A Review of the Millstone 3 Probabilistic Safety Study

A. A. Garcia, D. L. Bernreuter, T. E. McKone, P. D. Smith (LLNL), P. J. Amico (Applied Risk Technology Corporation), J. W. Reed, M. W. McCann, Jr. (Jack R. Benjamin & Associates, Inc.), P. R. Davis and G. Apostolakis (Consultants)

Prepared for
U.S. Nuclear Regulatory Commission

Manuscript Completed: December 1985
Date Published: April 1986

Fig. 3.2-1 Large LOCA event tree.

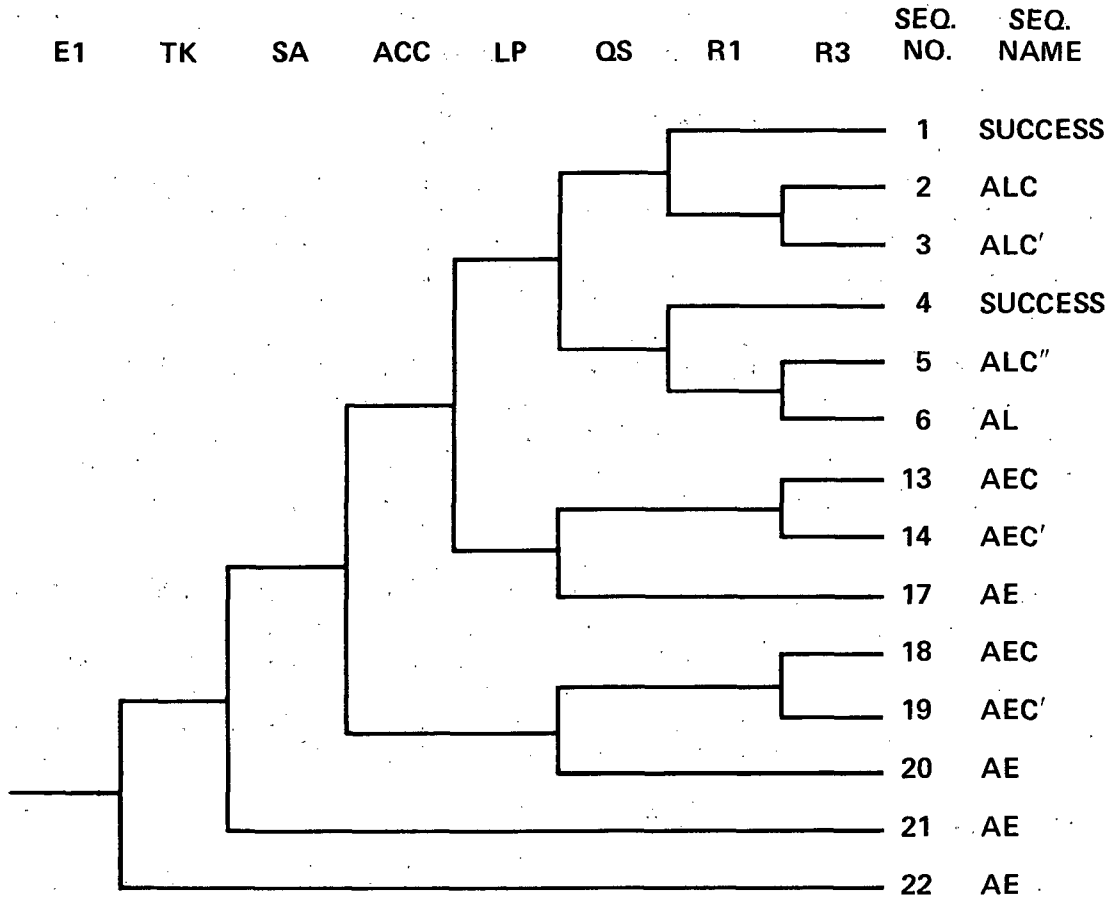
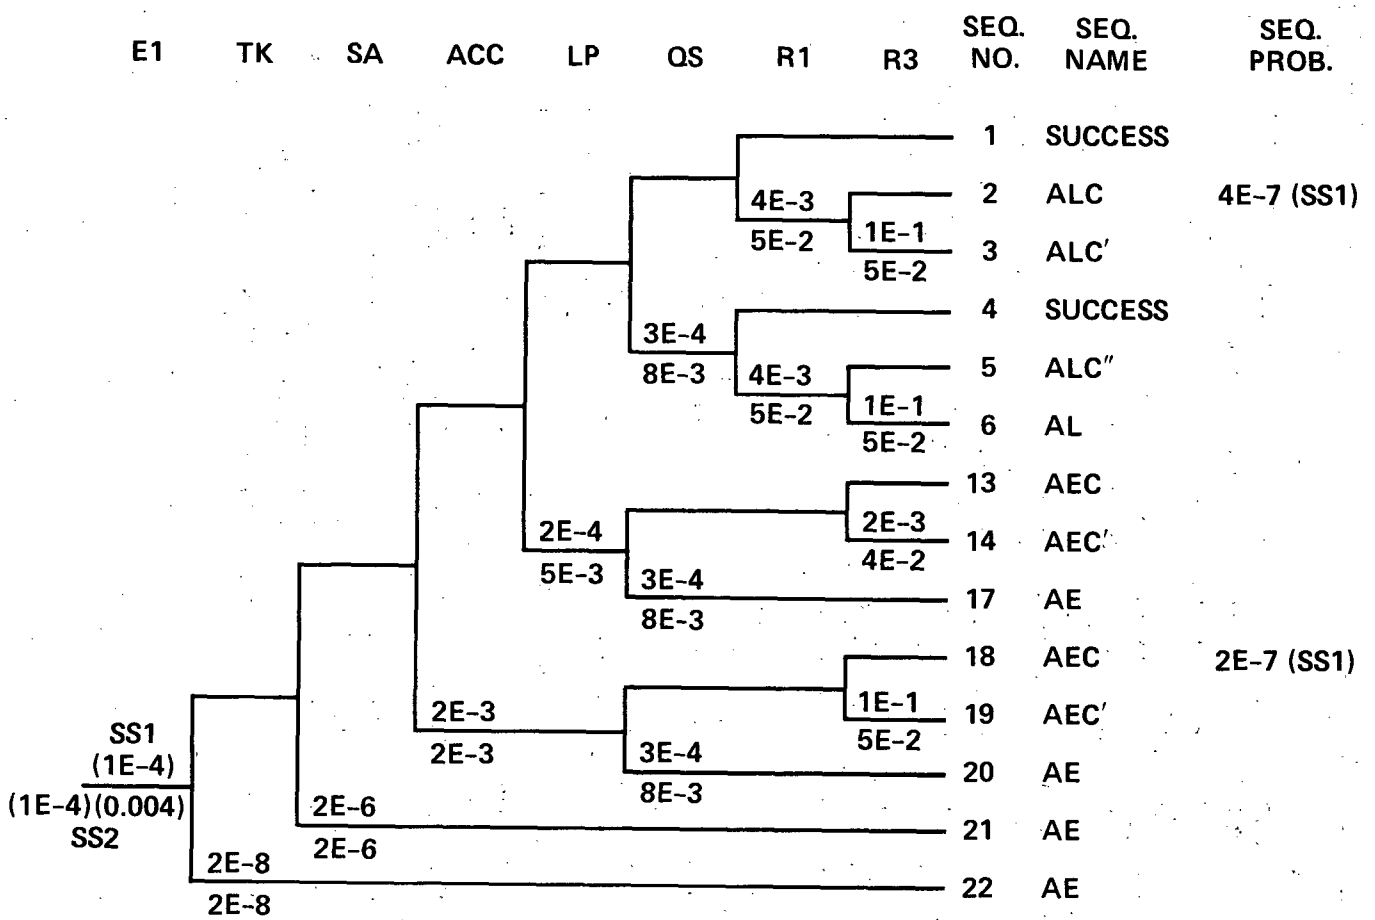
amounts of water through the suction lines. At this point, pump cavitation could occur and the pump could trip on low suction pressure or overspeed. If pump trips are not provided, as is the case at Millstone, the pumps could be destroyed. In either case, the pumps would not be able to provide coolant to the RCS. There is no reason to believe that the Millstone pumps are immune to this phenomenon, and the assumption that HPI could supply injection during large LOCAs is not justified. The event tree shown in Fig. 3.2-1 has been modified to reflect this judgment.

Fig. 3.2-5 Steam generator tube rupture event tree.

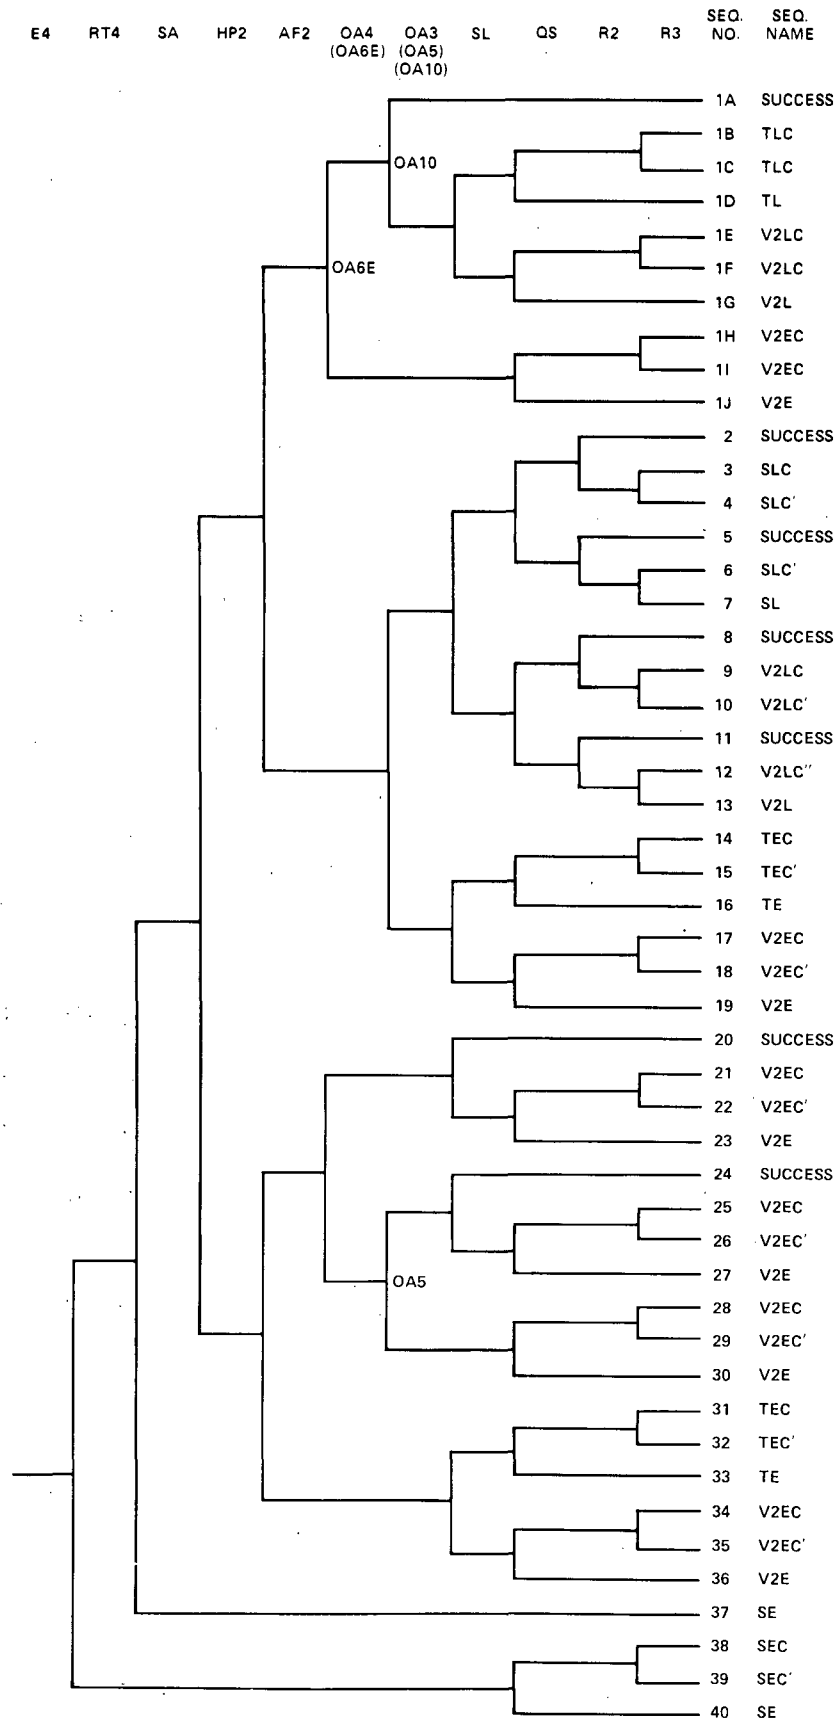
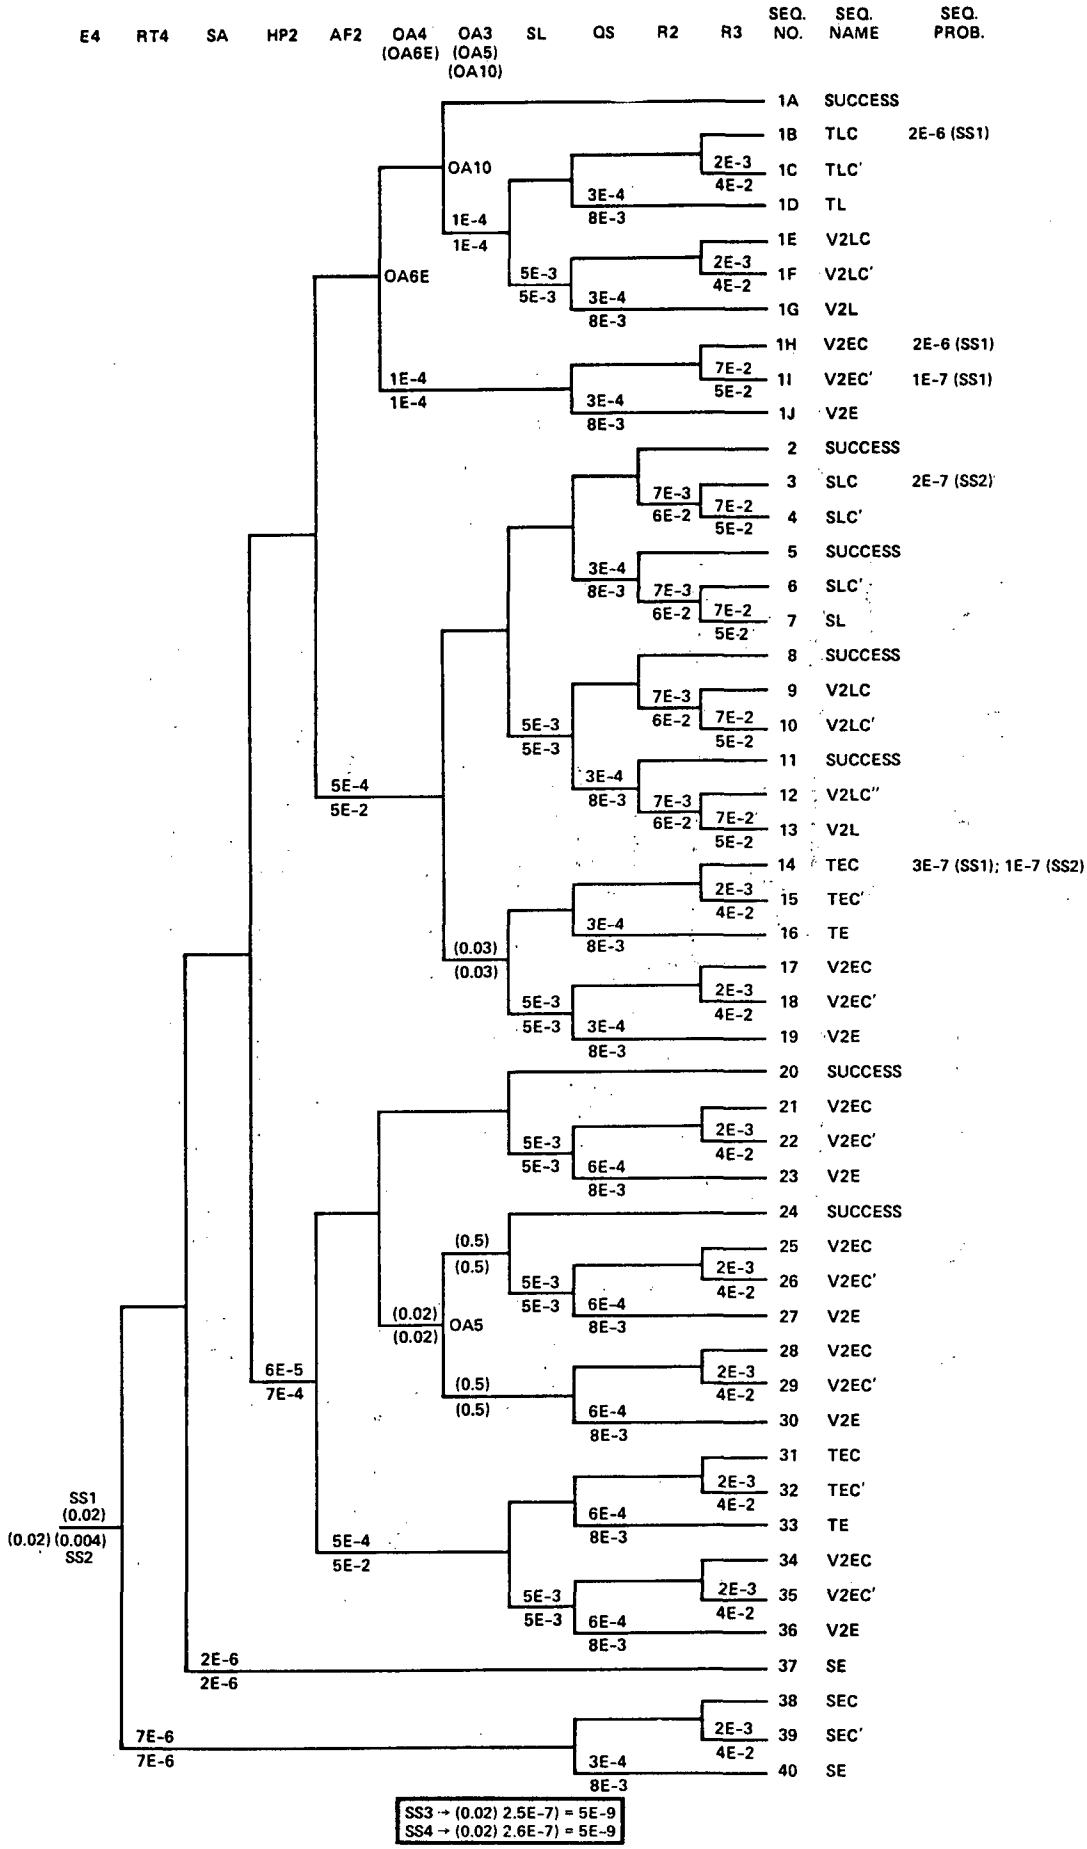
The SGTR tree shown in Fig. 3.2-5 has been modified to include this action.

Fig. 3.2-6 Steamline break insure (and outside) containment event tree.

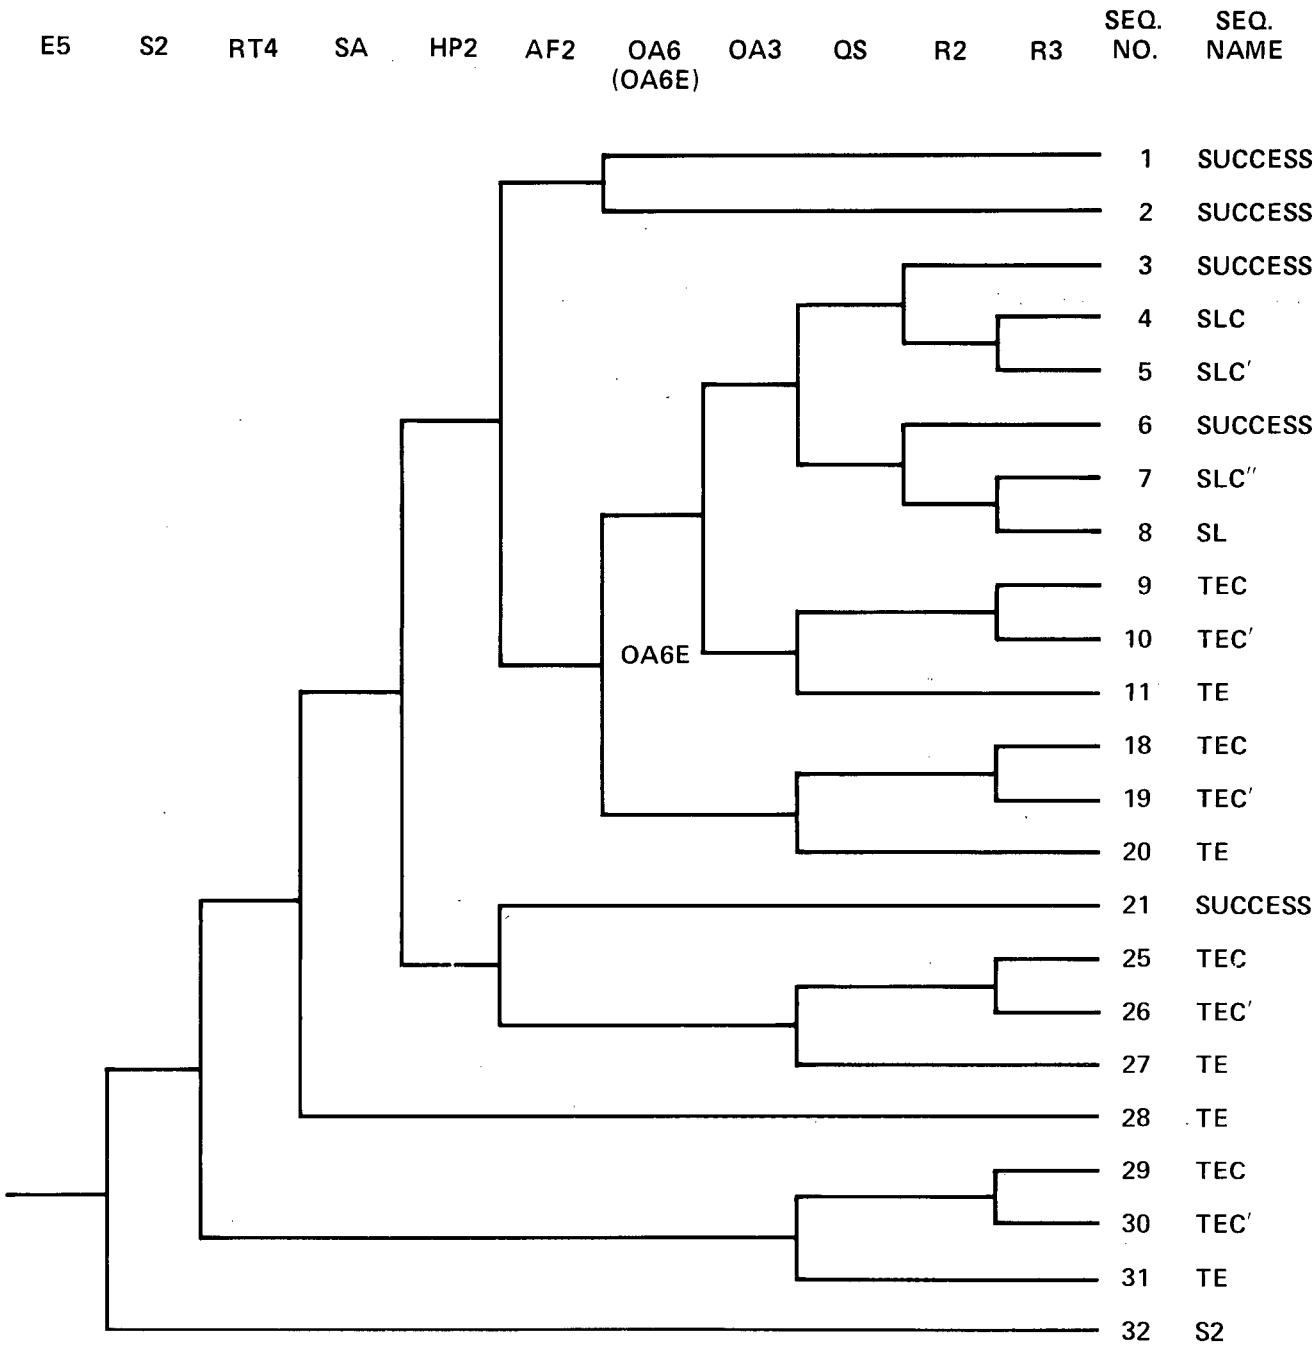
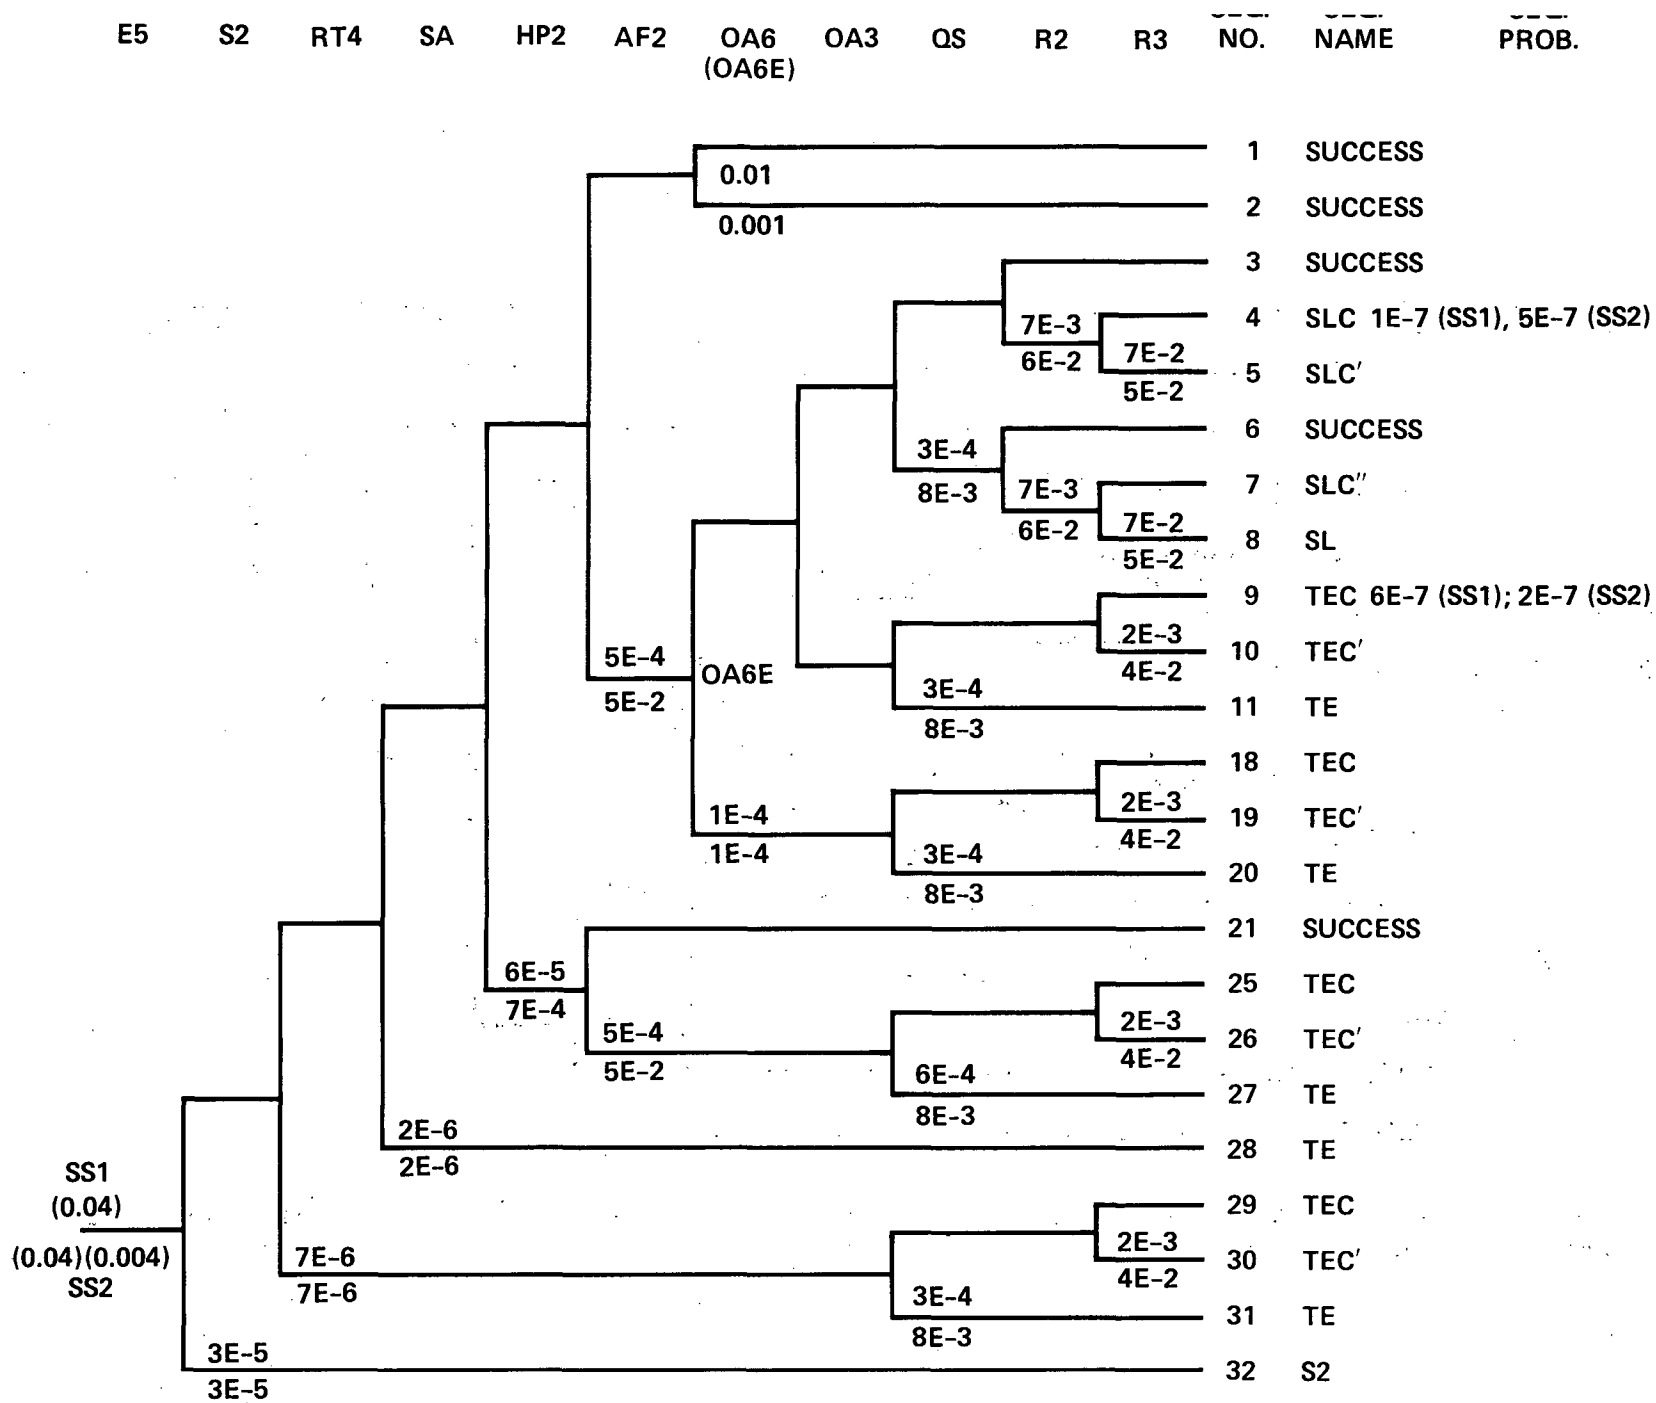
For steamline breaks, the PSS assumes that the failure of main steam isolation (MSI) results in the failure of auxiliary feedwater. The basis for this assumption is unclear, and there seems to be no reasonable explanation for it. In most previous PRAs, main steam isolation has not been assumed to have any affect on the availability of safety systems and was considered only as a key part of the containment isolation system. In the case of auxiliary feedwater, the worst one could assume is that the failure of MSI could affect the availability of the steam-turbine-driven AFW pump due to steam diversion, although this would be unlikely, since very little steam is required to operate this pump. Specifically, for the most likely break, a stuck-open secondary steam relief valve, the flow diversion would be small enough that the steam supply to the turbine would still be sufficient to provide required feedwater flow regardless of the state of MSI. For the less likely case of a major rupture of the steam line, the turbine-driven pump would definitely fail if none of the steam generators were isolated from the break. In either case, the ability of the motor-driven pumps to supply water to the steam generators would not reasonably be expected to be affected. As long as water is supplied in sufficient amounts, cooling will be established regardless of main steam isolation. This assumption is conservative and unjustified. The steamline break trees shown in Fig. 3.2-6 have been modified to reflect this judgment.
